8V19N880 REV B	
Doc Number	8V19N880
Rev	B
Date	2023-08-24

8V19N880 EVB REV B	
Doc ID	Document Number
Rev	Revision
DATE	DATE

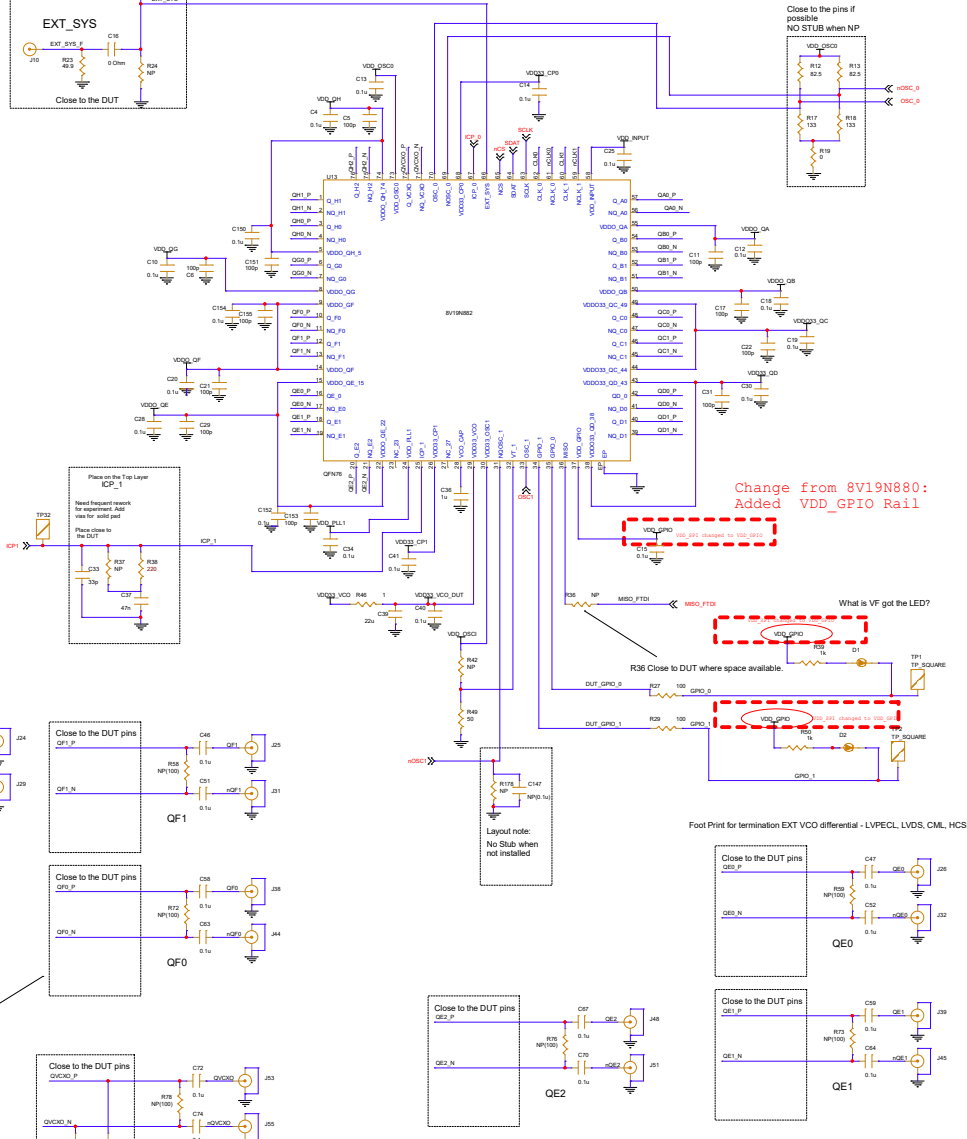
Layout note: No Stub when the components are NP (No Pop)

Changes from 8V19N880:  
 Added VDD\_GPIO  
 Removed Q\_A1/nQ\_A1  
 Removed Q\_G1/nQ\_G1  
 Removed CLK2/nCLK2  
 Removed CLK3/nCLK3

REV B change note:  
 VDD33\_OSCI pin can be 3.3V or 1.8V

Foot Print for termination EXT VCO differential - LVPECL LVDS, CML, HCSL

For LVPECL output driver, change the outputs without pull resistor to DC coupling (change Cap to 0 Ohm)

### EXT VCXO - PLL2

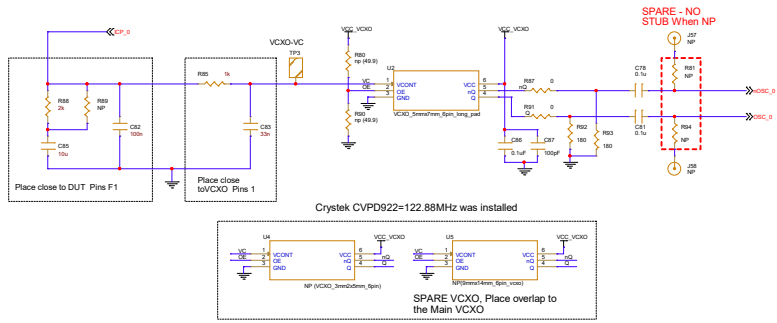
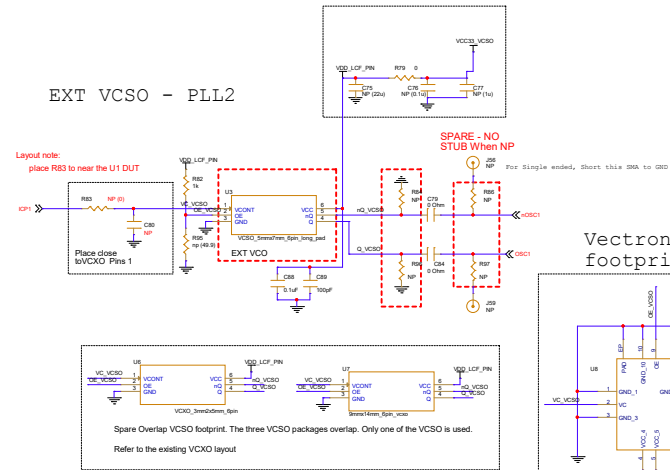
Vectron 10 pin spare footprint.

Add Multiple footprint option for ext VCO

Layout note:

No Stub on Q and nQ when spare are not installed.

10 pin Overlap to 6 pin may not be possible, Add resistors to isolate stub if needed.

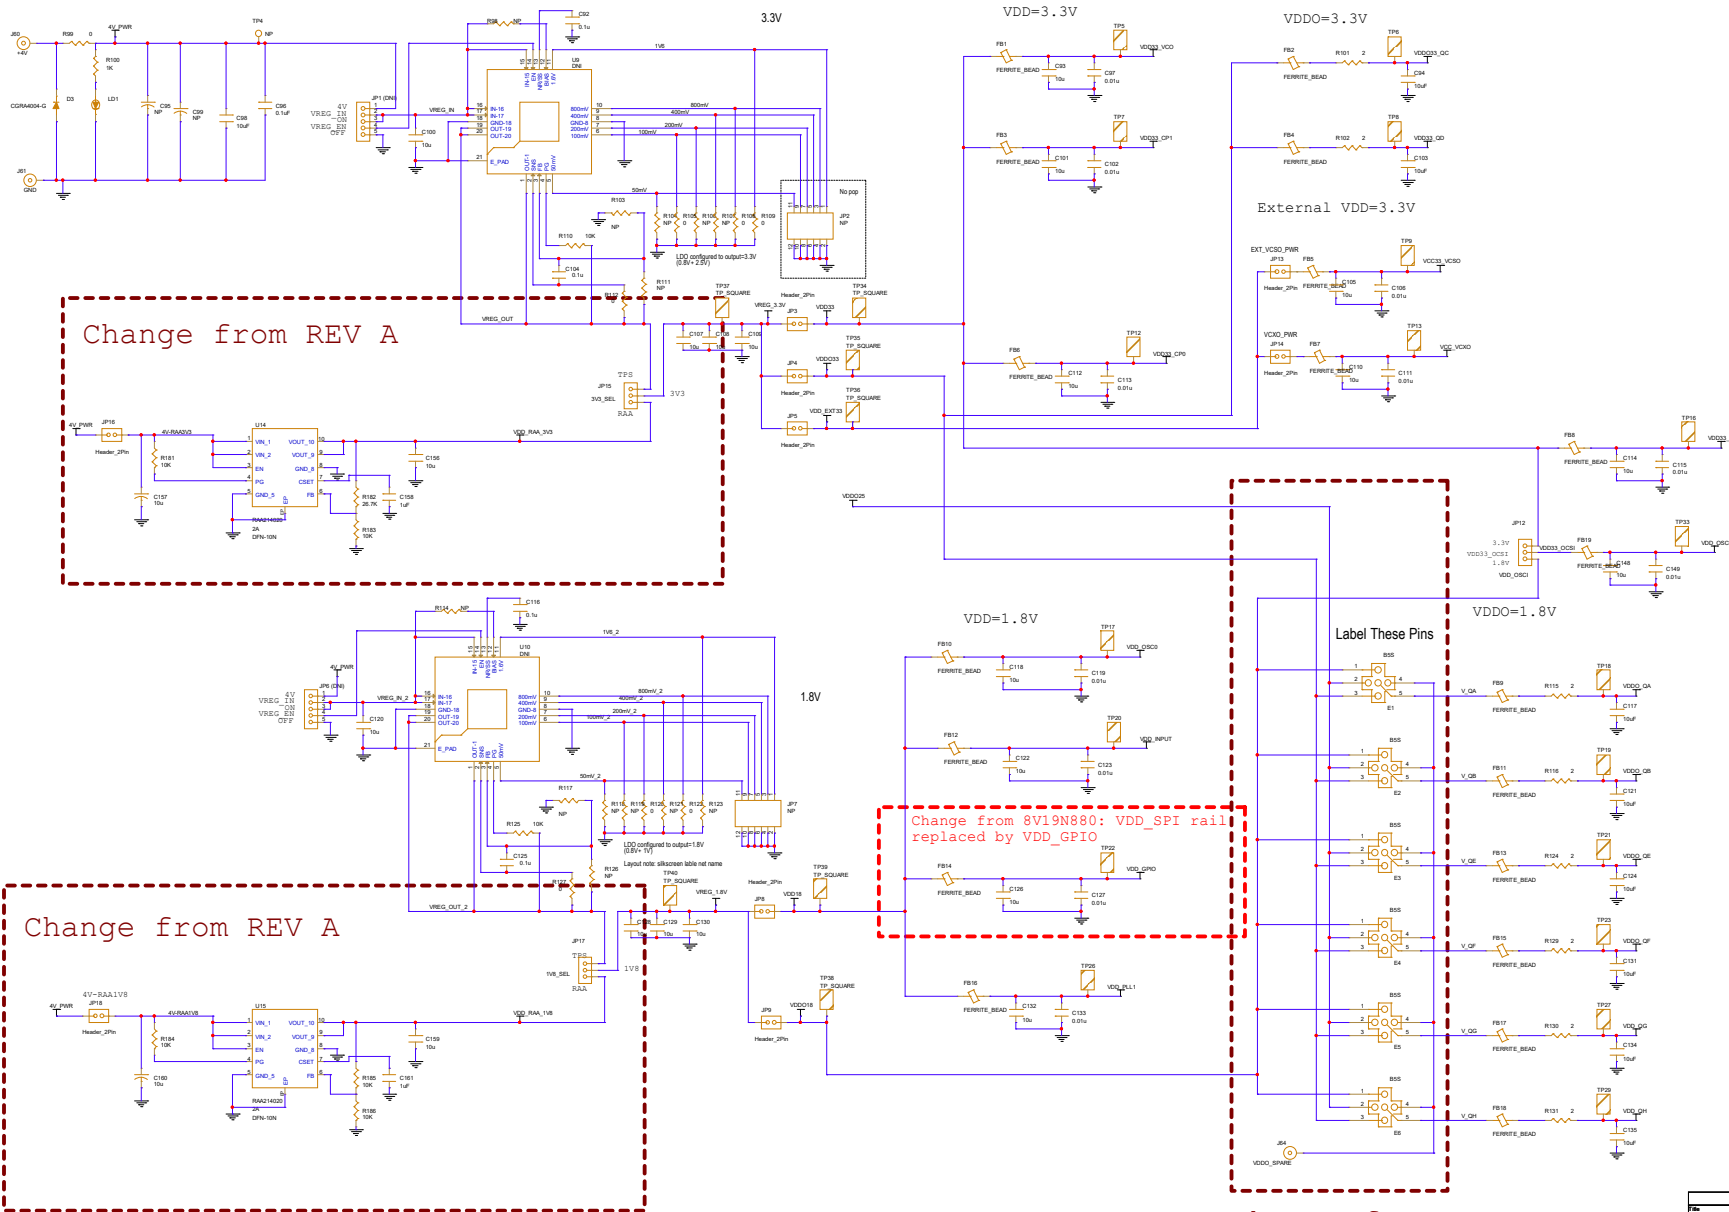
Change from REV A

Change from REV A

Change from 8V19N880: VDD\_SPI rail replaced by VDD\_GPIO

Label These Pins

Change from REV A

Rev		SYN8822-016 REV B	
Doc	Document Number		
ID	Doc		
Rev	Rev

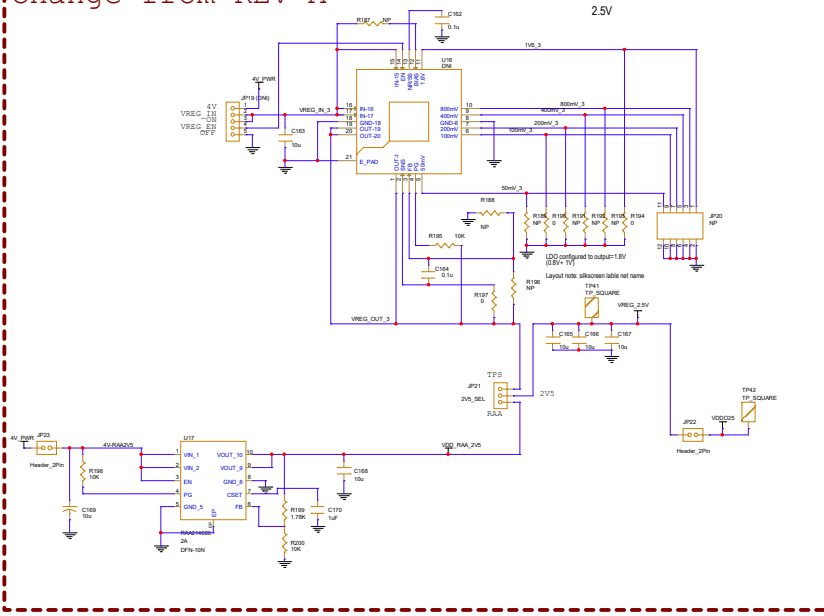
Change from REV A
